Donald C. Cook Nuclear Plant Units 1 and 2
INDIVIDUAL PLANT EXAMINATION
RESPONSE TO NRC AUDIT CONCERNS AND REQUEST
FOR ADDITIONAL INFORMATION

Donald C. Cook Nuclear Plant
Individual Plant Examination

Human Reliability Analysis Summary of Methodology
Changes and Example Calculations

FIGURE E-8
HPR1 FAULT TREE

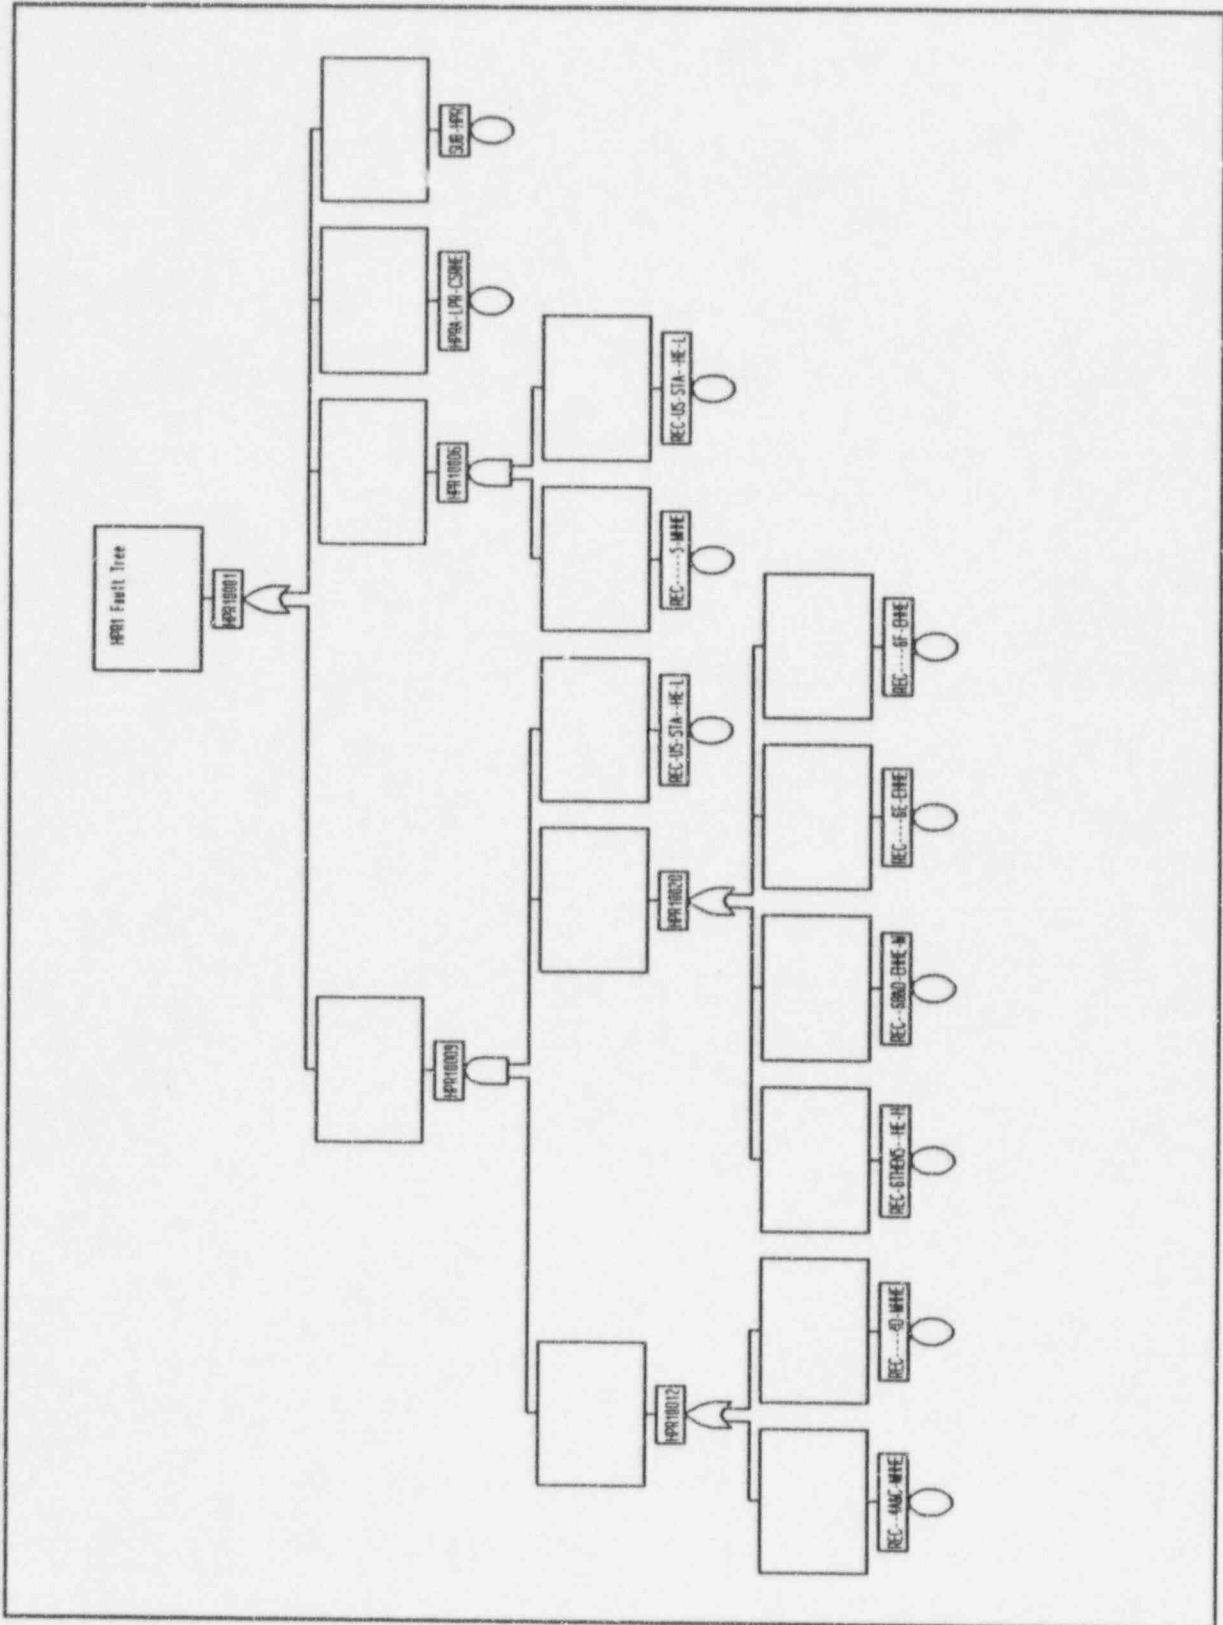
The total human error probability (THEP) for failing to switchover to high pressure recirculation upon a small LOCA and successful AFW (AFW) is calculated as shown in fault tree HPR1:

$$THEP(HPRA) = pc' + [pe'(\text{step } 4) * pe'(\text{step } 6) + pe'(\text{step } 5)] * \text{recovery}(\text{extra US or STA})$$

$$\text{THEP(HPRA)} = 1.5\text{E-}04 + [(5.2\text{E-}03 + 2.6\text{E-}03) * (0.5 + 1.4\text{E-}01 + 6.5\text{E-}03 + 1.3\text{E-}02) + 5.2\text{E-}03] * 5.0\text{E-}02$$

$$\text{THEP(HPRA)} = 6.7\text{E-}04$$
